SUBJECT: UNIT 1 CYCLE 10 TECHNICAL SPECIFICATION AMENDMENT (TAC 67143)

CALVERT CLIFFS NUCLEAR POWER PLANT, UNIT 1

Amendment No. 130
License No. DPR-53

SAFETY EVALUATION BY THE OFFICE OF NUCLEAR REACTOR REGULATION
RELATED TO AMENDMENT NO. 130 TO FACILITY OPERATING LICENSE NO. DPR-53
BALTIMORE GAS AND ELECTRIC COMPANY
CALVERT CLIFFS NUCLEAR POWER PLANT, UNIT 1
DOCKET NO. 50-317

Figure 3.2-2
 Linear Heat Rate Axial Flux Offset Control Limits

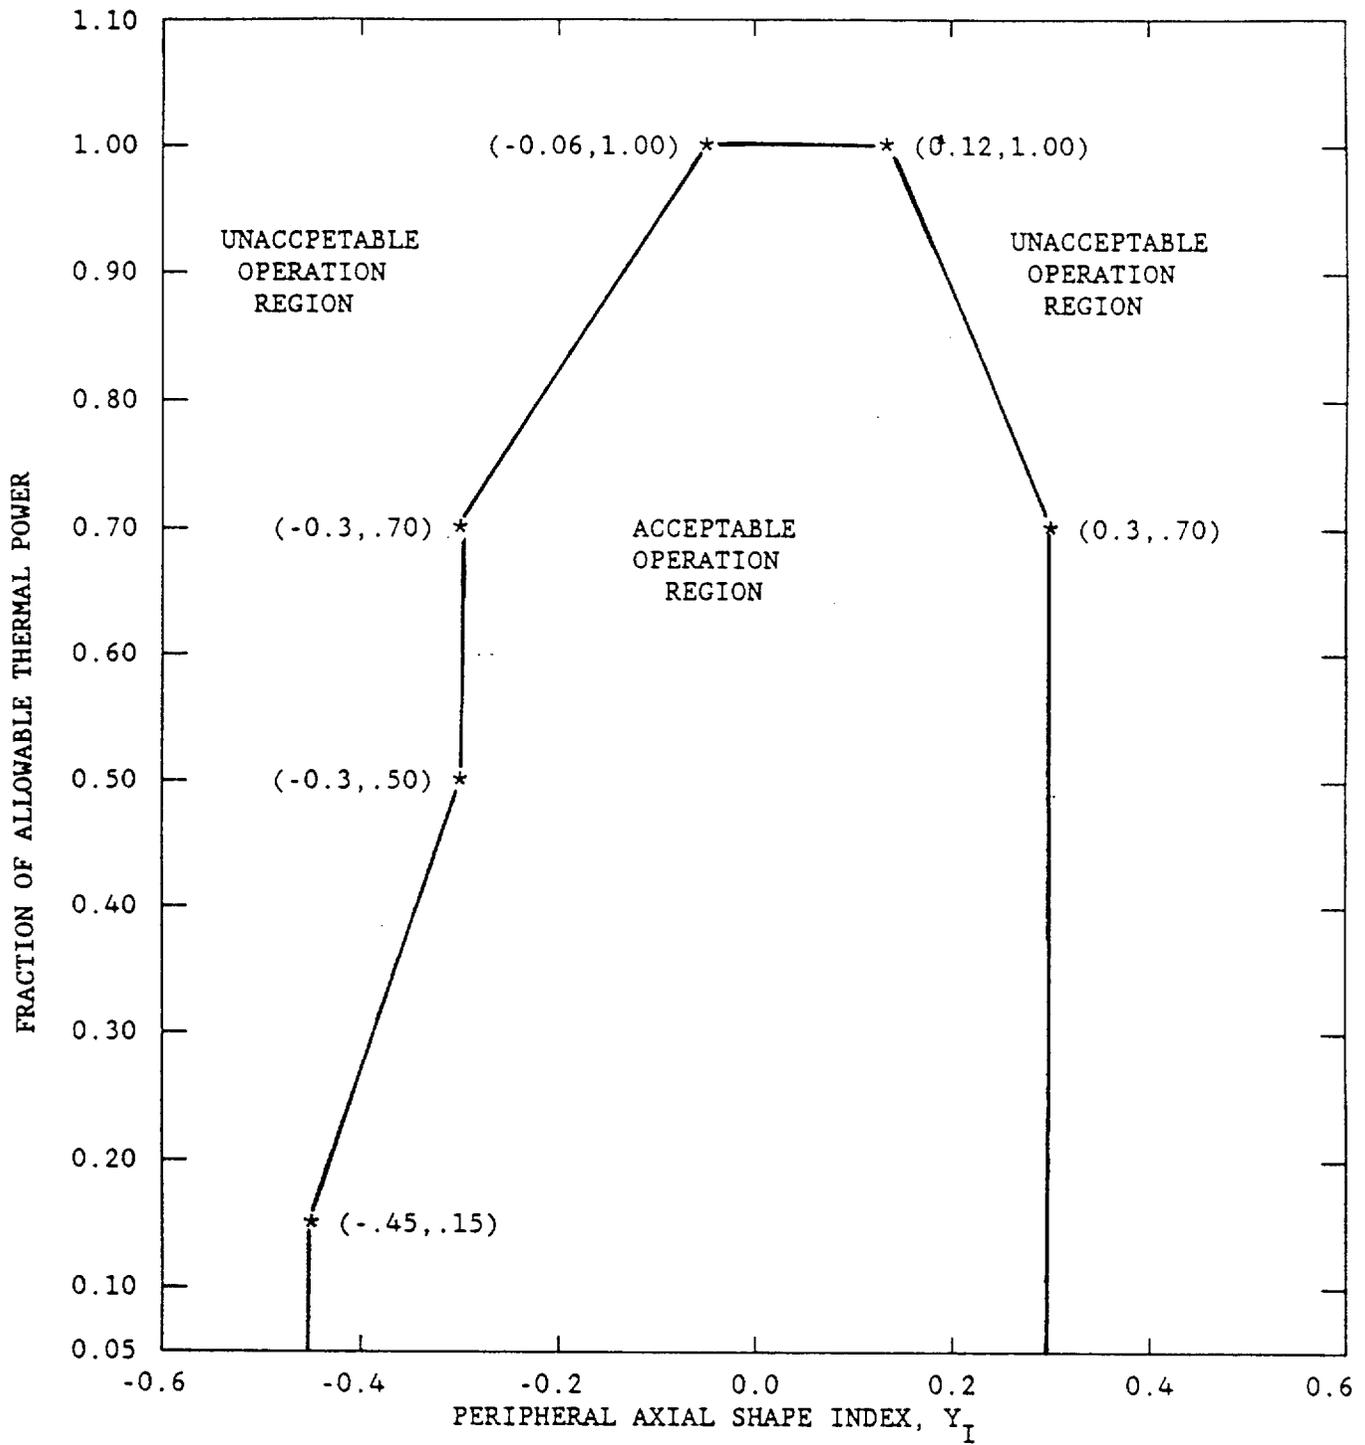
- b. expanding the acceptable operation region of TS Figure 3.2-2, "Linear Heat Rate Axial Flux Offset Control Limits," and TS Figure 3.2-4, "DNB Axial Flux Offset Control Limits," by increasing the negative ASI limit below 50% RTP from the current value of -0.3 to

- (1) between 15% and 50% RTP, the linear equation for the negative ASI limit = $-[0.3 + 3/7 (.5-P)]$, where P is the fraction of RTP;
- (2) below 15% RTP, the negative ASI limit = -0.45.

6.8 Figure 3.2-2 Linear Heat Rate Axial Flux Offset Control Limits And Figure 3.2-4 DNB Axial Flux Offset Control Limits

These Figures are modified to increase the negative ASI limits below 50% power. The licensee has evaluated the effect of the proposed new limits on the Unit 1 Cycle 10 and Unit 2 Cycle 8 transient analyses, margin to fuel centerline melt limits, margin to DNB limits, margin to LOCA PLHGR limit, core power versus planar radial peaking factor LCO, TM/LP LSSS, and core power versus integrated radial peaking factor LCO and has determined that acceptable results are obtained. The changes are, therefore, acceptable for Unit 1 Cycle 10 and Unit 2 Cycle 8.
